## City of Mississauga Department Comments

Date Finalized: 2023-04-05 File(s): A72.23

The applicant requests the Committee to approve a minor variance to allow the construction of a new dwelling proposing a height of 8.50m (approx. 27.88ft) whereas By-law 0225-2007, as amended, permits a height of 7.50m (approx. 24.6ft) in this instance.

Property Address: 1640 Glenburnie Road

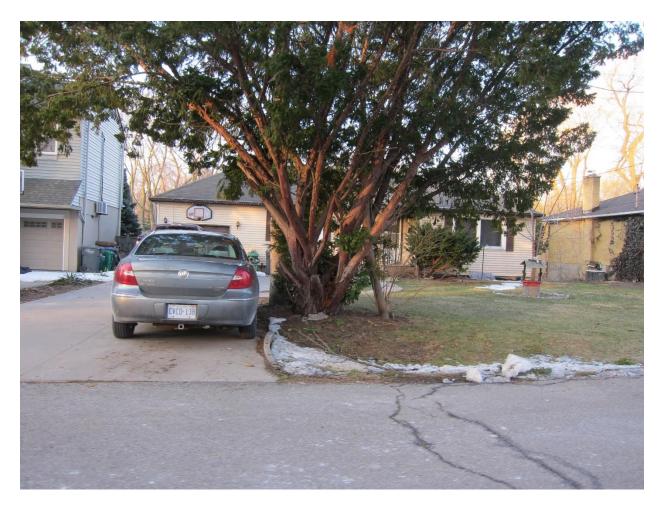
Staff have no concerns with the proposed height of the dwelling from the façade. However, staff note that the property slopes downward from front to back. As the property slopes downward, this has the effect of creating a greater flat roof height when viewed from both the northerly and southerly sides of the dwelling. Staff have concerns that the massing of the dwelling will negatively impact the adjacent properties to the north and south. The sides of the dwelling have heights ranging from 7.86m- 9.68m (north side) and 7.97m-9.97m (south side) when measured from the grade at where the dwelling sits. This represents a significant deviation from the 7.5m (24.6ft) maximum requirement. Furthermore, when viewing the dwelling from the rear, and portions of the sides, the dwelling appears to contain three-storeys due to a walk out basement condition.

As such, staff is of the opinion that the proposal fails to meet the four tests and recommend deferral of the application to redesign the dwelling.
